DEFENSE NUCLEAR FACILITIES SAFETY BOARD

Staff Report

Alternate Location for the Co-Located Worker at the U1a Complex

Figure 1. Aerial view of the U1a Complex and Area 6 construction facilities

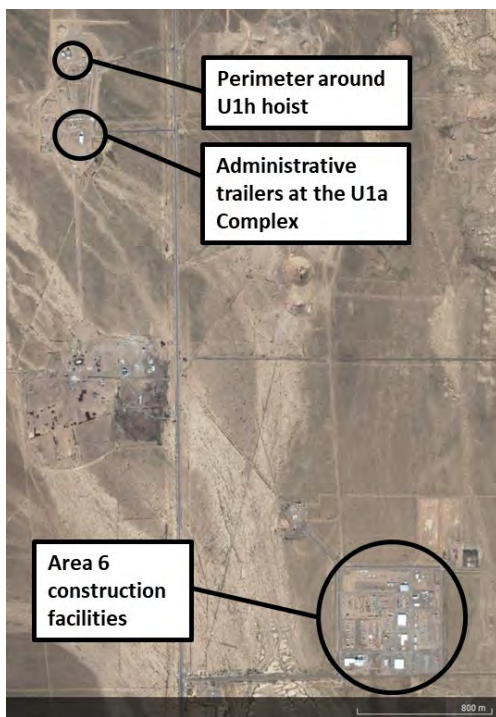
For example, even if the guidance in DOE Standard 3009-2014 were applicable to the major modification projects at the U1a Complex, the staff team concludes that moving the assumed location of the co-located worker to the Area 6 construction facilities is inappropriate. This location is approximately 3,500 meters from the U1a Complex and fails to take into account workers located in the administrative trailers or parking lot at the U1a Complex, which are

approximately 400 meters from the U1h hoist (location where the subcritical experiment package is lowered into the facility). In addition, MSTS plans to replace the administrative trailers by constructing two new support buildings at the U1a Complex to support the expected increase in personnel due to the expansion of the programmatic mission at the facility [12]. Figure 1 below highlights the distance between the U1a Complex and the Area 6 construction facilities.
